# Material In Response to D1.1 Comments

## IEEE 802.3bp - Interim Meeting - January 2015

## Comment #92

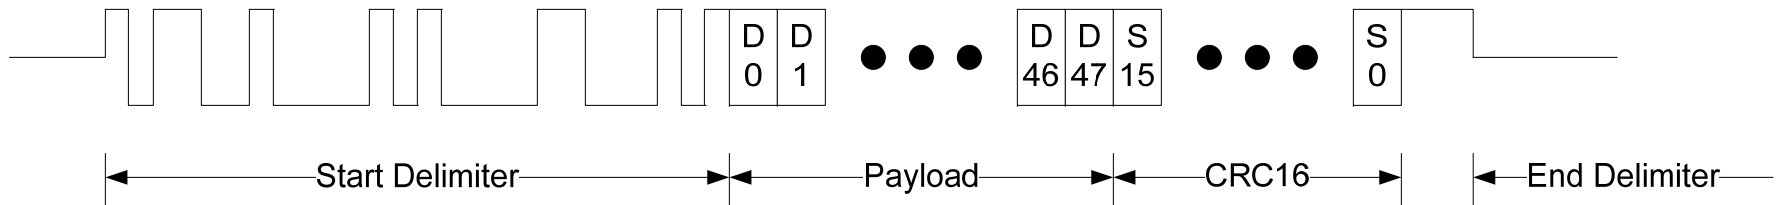
▶ **If proposal to reduce end delimiter is accepted**

- Use this diagram instead
